APPLICATION NO.	FILING DATE	FIRST NAMED INVENTOR	ATTORNEY DOCKET NO.	CONFIRMATION NO.
10/802,203	03/17/2004	Roy J. Blazek	34282	3763
Hovey Willian	7590 01/24/2007 ns LLP		EXAM	INER
Suite 400 2405 Grand Blvd. Kansas City, MO 64108			GREEN, PHILLIP	
			ART UNIT	PAPER NUMBER
			2823	
· · · · · · · · · · · · · · · · · · ·	· · · · · · · · · · · · · · · · · · ·			•
SHORTENED STATUTORY PERIOD OF RESPONSE		MAIL DATE	DELIVERY MODE	
3 MONTHS		01/24/2007	PAPER

Application No.	Applicant(s)				
	10/802,203	BLAZEK ET AL.				
Office Action Summary	Examiner	Art Unit				
	Brook Kebede	2823				
The MAILING DATE of this communication appears on the cover sheet with the correspondence address Period for Reply						
A SHORTENED STATUTORY PERIOD FOR REPLY IS SET TO EXPIRE 3 MONTH(S) OR THIRTY (30) DAYS, WHICHEVER IS LONGER, FROM THE MAILING DATE OF THIS COMMUNICATION. - Extensions of time may be available under the provisions of 37 CFR 1.136(a). In no event, however, may a reply be timely filed after SIX (6) MONTHS from the mailing date of this communication. - If NO period for reply is specified above, the maximum statutory period will apply and will expire SIX (6) MONTHS from the mailing date of this

In response to applicants argument, it is respectfully submitted that Rutt discloses all the claimed limitations of claims 1, 7 and 11 as set forth above. For instance, Fig. 7 as shown below:

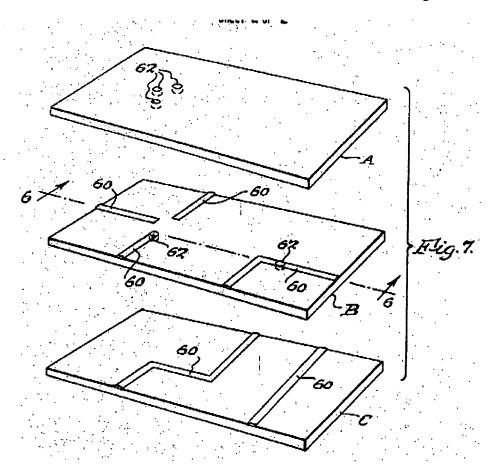
Applicants argue that "Rutt does not disclose printing circuit components onto an individual layer substrate; firing the layer of substrate and the circuit component printed there on..."

As depicted above, individual layers A, B, C contain, structures 60 and 62 are formed using screen print (see Col. 11, liné 60 – Col. 12, line 28) and the elements 60 and 62 are also

part of circuit components. In addition, Rutt discloses firing of small ceramic units or chips to sinster them into unitary bodies (see Figs. 6 and Col. 11, lines 9-60) which is analogous to "printing circuit components onto an individual layer substrate; firing the layer of substrate and the circuit component printed there on," as recited in claims 1, 7 and 11.
